EMERALD ESTATES
RAMSEY, MINNESOTA

FILE NAME 2024-09-19 GREENWALDT PROPERTY SKETCH PLAN.DWG
PROJECT NO. ZZZZ24725

SKETCH PLAN

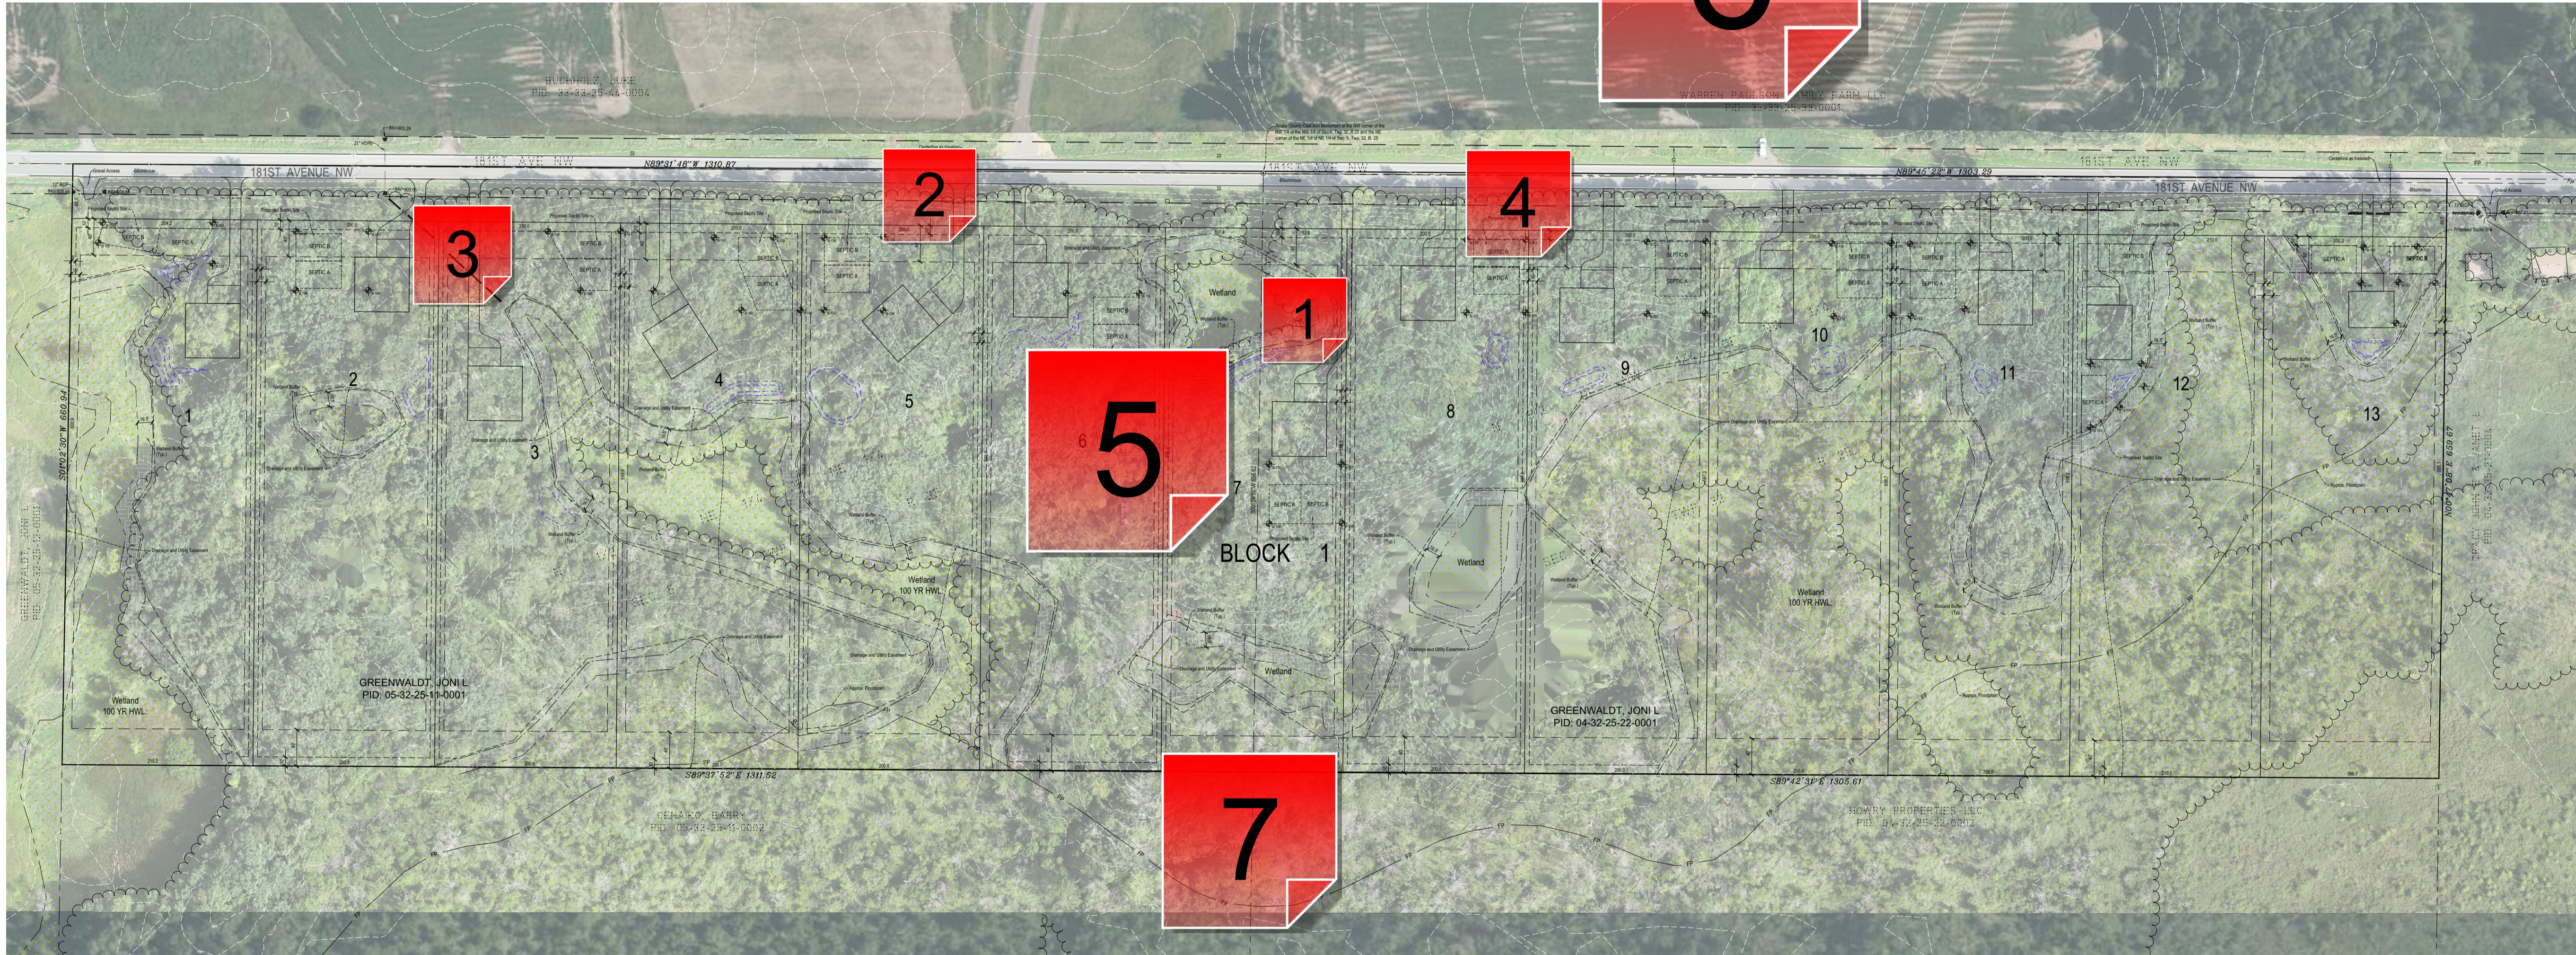
The driveway on lot 7 is shown encroaching onto Lot 8. Would it be possible to adjust the widths of Lots 1 and 12, both of which have just slightly more width than required, and then adjust width of Lot 7 to see if that could result in this driveway staying entirely on Lot 7?

Please make sure to coordinate with Anoka County to ensure the driveway culverts meet their minimum culvert size.

The Final Plat will need to include an easement to encumber this stormwater pipe.

Please add proposed well locations to this sheet. While the lots are 2.5+ acres in size, due to wetlands and floodplain, some have very limited areas for homes, septic, alternate septic location, and well. Showing the proposed well locations now helps to confirm that there is sufficient space between well and septic (including a septic that may be on an adjacent lot).

A tree inventory and preservation plan will be required with the Preliminary Plat submittal. All significant trees need to be inventoried. This includes all oaks and evergreens that have a DBH of 4" or greater and all other deciduous trees that have a DBH of 8" or greater. The inventory needs to include species, DBH, condition, status (save or remove), removal description (e.g. mass grading, stormwater pond, etc.), tally of total significant tree DBH inches, tally of DBH inches removed, tally of DBH inches of invasive species (these are exempt from the removal threshold).

Anoka County Highway Department requested a meeting with city staff about this project. We met (virtually) with them on 9.30.24 to discuss the project. They have concerns about the number of direct access points on to a county highway and would prefer if an alternative design could be found to reduce (or eliminate) the number of direct access points. Possible alternatives could include concepts such as a frontage road, maybe a modified right turn lane on 181st, or a cul-de-sac or two so that access could be shifted to a local road. They will be sending over written comments. Once received, we will forward them to you.

It would be wise for the Greenwaldts (or Landform on their behalf) to contact the owners of the two 20-acre parcels to the south. The 2 parcels are landlocked, and it would be beneficial to get their input on potential access routes to their parcels. Should they petition for a 'cartway', the city will be obligated to provide a 33 foot wide access corridor to their parcel(s) and it would likely need to come from the north through high and dry land rather than impacting wetland.
